ISO/TC 197  
Hydrogen technologies

**ISO CD 19880-5.2 - Collated comments with resolutions**

Date of document: 2018-02-13

Background: Here are the collated comments from the CD2 ballot complete with the resolutions from WG 22.

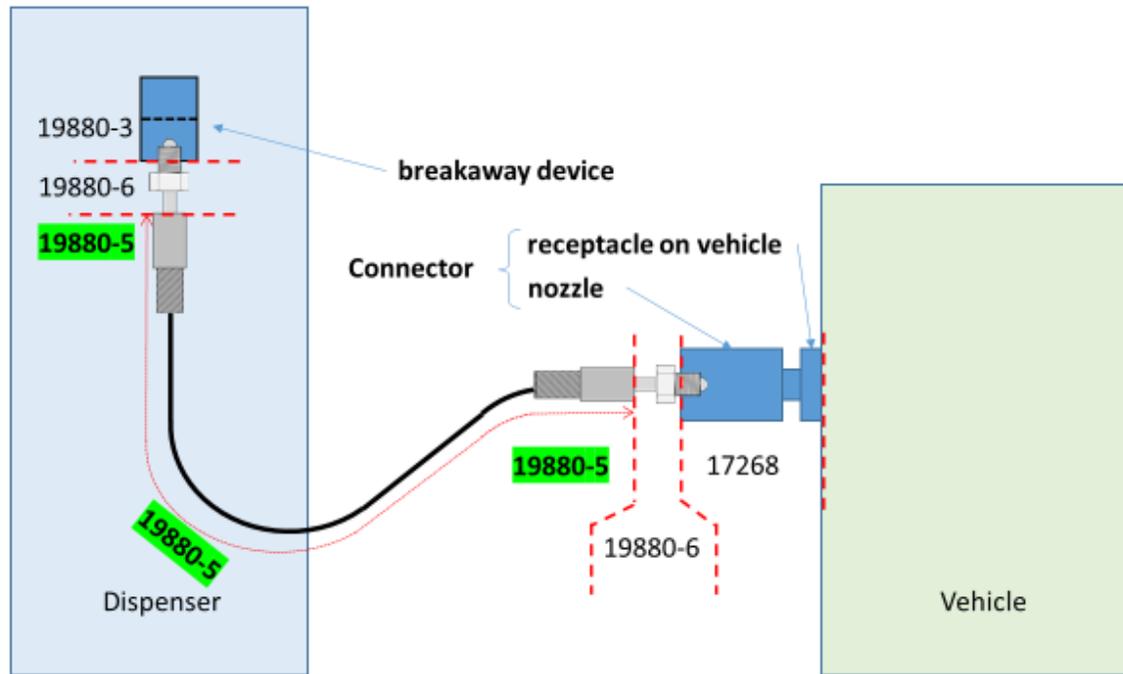
| MB/NC <sup>1</sup> | Line number | Clause/ Subclause | Paragraph/ Figure/ Table/ | Type of comment <sup>2</sup> | Comments   | Proposed change                 | Observations of the secretariat  |
|--------------------|-------------|-------------------|---------------------------|------------------------------|--|---------------------------------|--|
| GB<br>163          |             | ?                 |                           | Ge                           | <p>Feedback/response to the note on ESD associated with ISO/TC 197/WG 22 N38:</p> <p>There is always a risk of static electricity and bonding and grounding are particularly important in hydrogen applications, but I expect that this static electricity would be from surroundings and not from hydrogen gas itself. Theoretically it could be from particles within the hydrogen gas, like rust or dust particles.</p> <p>However, there are no particles in the gas stream delivered to the car (as far as I am aware). So this static electricity does not explain to me how material degradation of the liner inside the dispenser can occur.</p> |                                 | <p>Not accepted</p> <p>There is no guarantee that the materials selected produce no static electricity.</p> <p>In reality, there will be (sub-micron) particles in the gas stream delivered to the car. It is considered that rapid flow of hydrogen gas or liquid inside the liner generates static electricity. There is a chance of dielectric breakdown of the liner depending on the lining material. That is why we specify the property of material to prevent from dielectric breakdown.</p> |
|                    |             |                   |                           |                              | See figure below – will WG 24 adopt?   |                                 | Agree in principle – WG 22 worked with Chair of WG 24 on a harmonized figure.  |

7.x Electrostatic Dissipative Properties of the hose liner

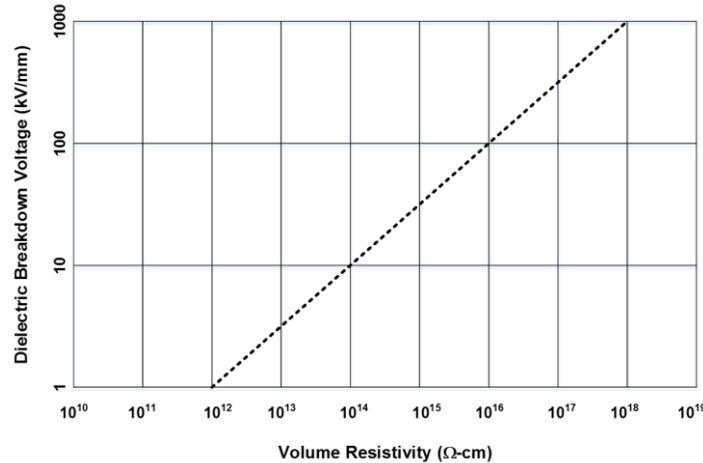
Determine the volume Resistivity of the hose liner per ASTM D257 or equivalent and the Dielectric breakdown strength of the hose liner per ASTM D 149 or equivalent and plot in the figure above. Hose liner material data to the left of the dotted line is acceptable. Hose liner material data to the right of the dotted line is questionable.
